## AGENDA MEMORANDUM

**Title:** **Dawson Trails Filing No. 2, Tract Q, Site Development Plan**  
[55.98 acres, located south of Territorial Road and west of Dawson Trails Boulevard]

Figure 2: Dawson Trails PD Planning Areas B1, E-2 and Public Land PL-2.02

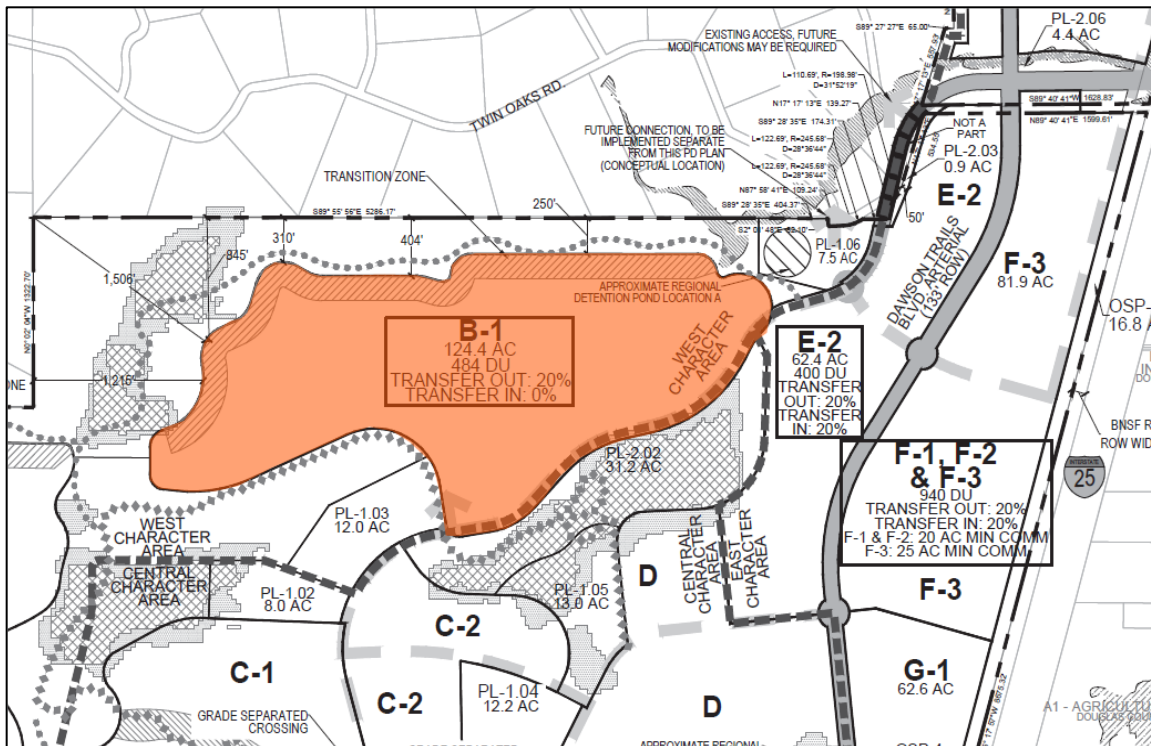
The property is located south of Territorial Road and west of the future Dawson Trails Boulevard, within Dawson Trails PD Planning Area B1 (PA-B1) and is undeveloped (Figure 2). The Douglas County subdivision of Twin Oaks is north of the site, and separated from the site by a minimum 250-foot open space buffer. Twin Oaks is an unincorporated large lot neighborhood of single-family homes.

PA-E2, a mixed-use area where single-family and multifamily residential development is intentionally mixed with a variety of commercial, office and retail uses. The western portion of PA-B1 allows an additional 255 single-family detached units. South of the site, across Gambel Ridge Boulevard, is 31.2 acres of public land zoned for passive recreational uses.

Figure 3: Dawson Trails Planning Area B1 Site Development Plan

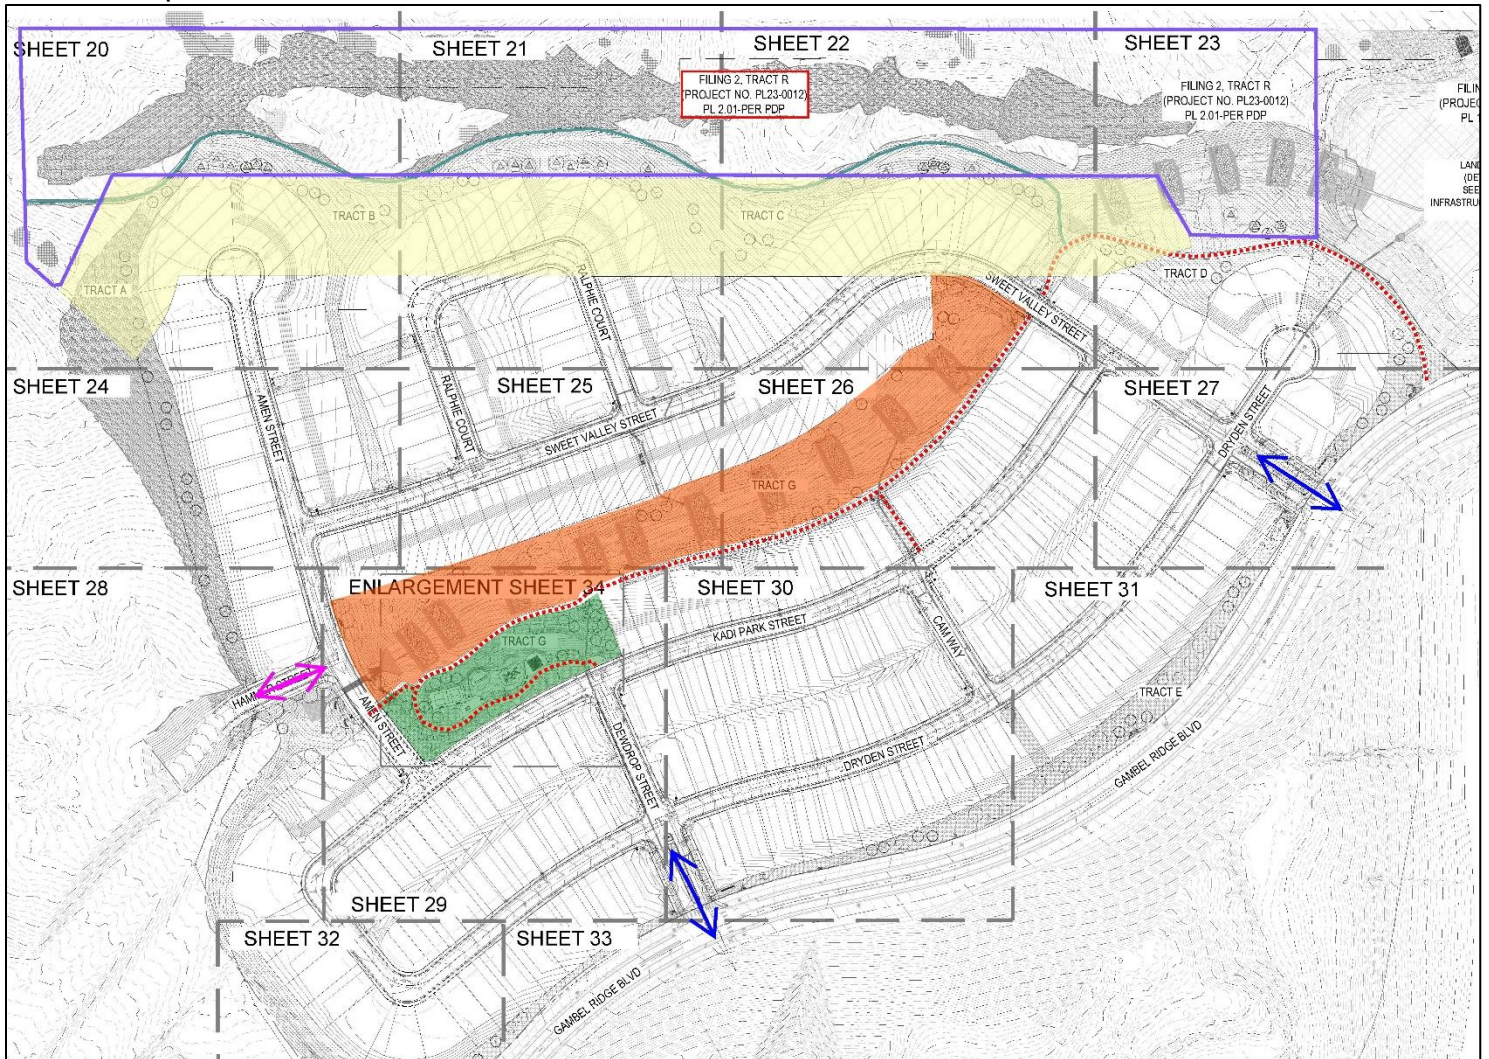
The SDP proposes 229 single-family detached residential units and 15 acres of private open space, which includes the neighborhood park (Figure 3, shaded green). Tract R (Figure 3, outlined in purple) is a minimum 250-foot open space buffer that separates this neighborhood from the Twin Oaks subdivision to the north. Tract R is part of a larger open space buffer that extends around the perimeter of the PD that will include a natural surface trail (Figure 3, solid teal line) and drainage improvement to be constructed by the developer.

A 150-foot wide transition zone (zone) exists along the northern tier of lots in PA-B1 (Figure 3, shaded yellow). The minimum lot size within the zone is 6,600 square feet (sf). This minimum lot size within the zone proposed with this SDP is approximately 7,700 sf.

There are two median separated access streets from Gambel Ridge Boulevard into the neighborhood (Figure 3, blue arrows). When the western half of Planning Area B1 is constructed, an internal collector road will connect the two neighborhoods and providing additional points of access to both neighborhoods (Figure 3, pink arrows).

Tract G is approximately 5.7 acres that traverses the neighborhood east to west and is a natural drainage channel that will serve as an internal buffer between within PA-B1 (Figure 3, shaded orange). The channel will be stabilized with the construction of this neighborhood.

An internal concrete trail is planned (Figure 3, red dashed line) that will traverse the neighborhood east to west. The trail will be extended west with the construction of the neighborhood in the western half of PA-B1.
